Project Name McDuffie Terminal Improvements – New Assembly and Shop Buildings

Project # 11411 **Task #** 3 **March 11, 2026**

ADDENDUM NO. 2

Item	Description
NOTES	
2	Revised Drawings (attached) Drawing No. 4617 E1 Drawing No. 4617 E2
3	Contractor Questions (attached)

McDUFFIE TERMINAL IMPROVEMENTS
NEW FABRICATION BUILDING PACKAGE
ELECTRICAL SERVICE PLAN & DETAILS

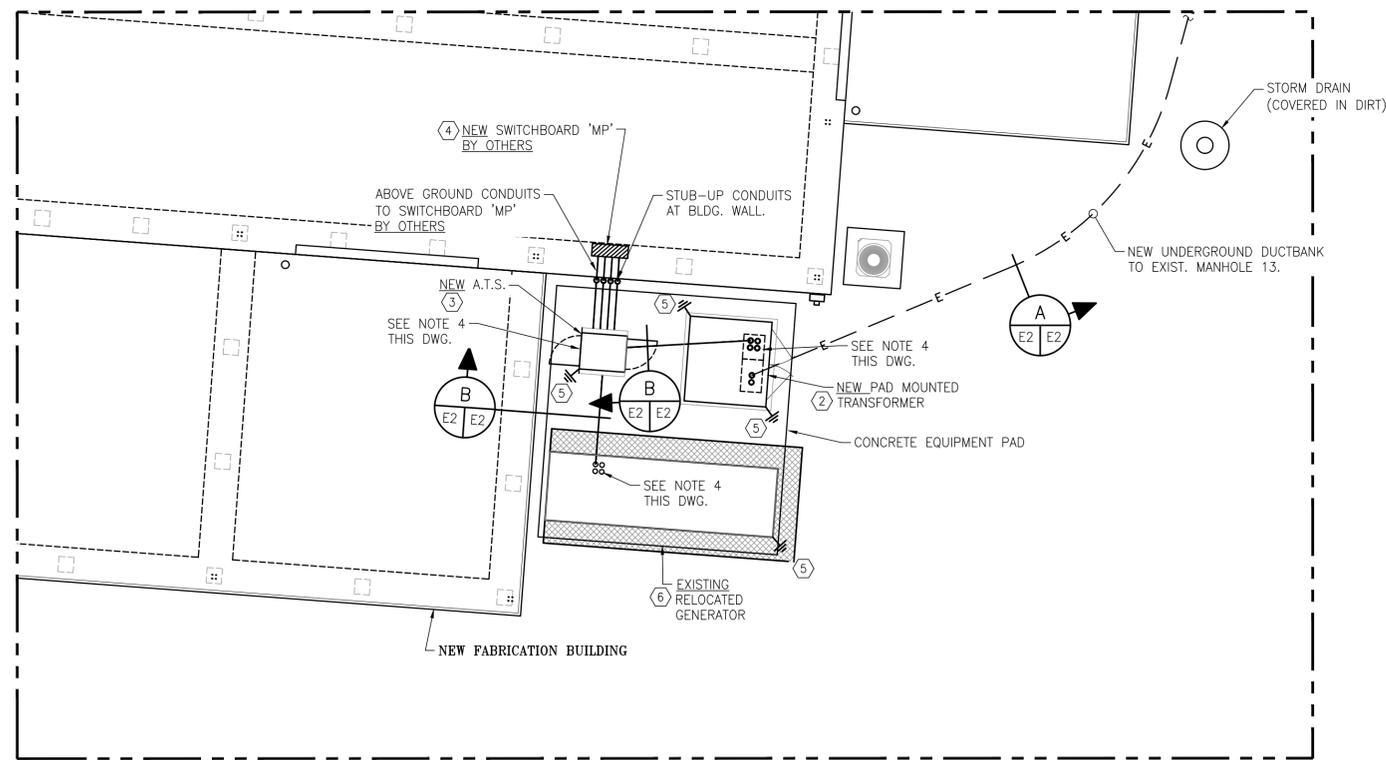
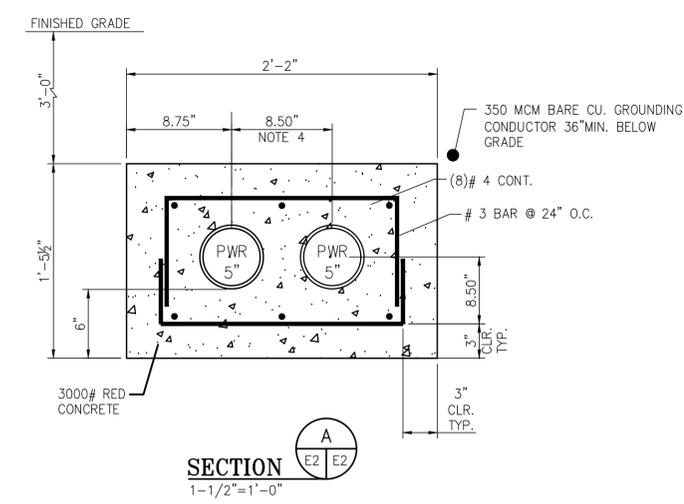
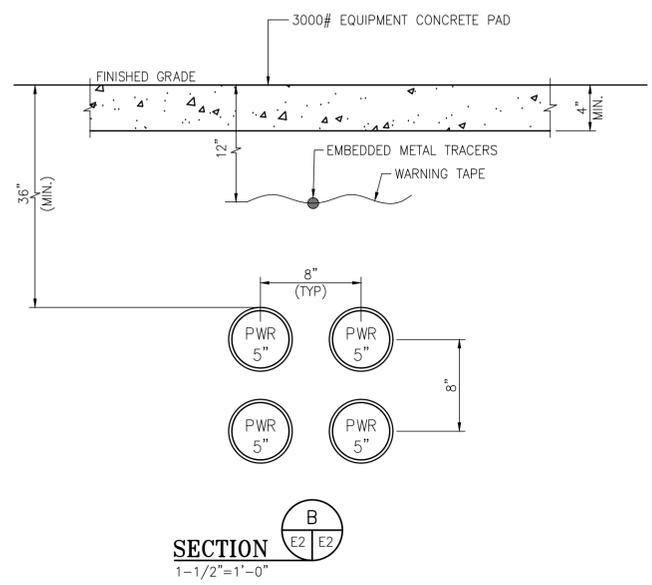
NO.	REVISION	DATE	DRAWN	CK'D	APPD	DATE
C	FEEDER REPLACEMENT OPTION CLARIFICATIONS; MODIFIED NOTE Δ	03-06-26	WMB	JEJ	RSG	
B	ISSUED FOR BID	01-14-26	WMB	JEJ	RSG	
A	100% DESIGN REVIEW	09-09-25	WMB	JEJ	RSG	
	REFERENCE DRAWINGS

- EXISTING 23KV LOAD INTERRUPTER SWITCH (L.I.S.) AND FEEDER CABLE FOR THE EXISTING WAREHOUSE BLDG TO BE REUSED FOR THE NEW FABRICATION BLDG. POWER. SEE DRAWING 4617-E1 SCOPE OF WORK NOTE 4 FOR ELECTRICAL SCOPE OF WORK.
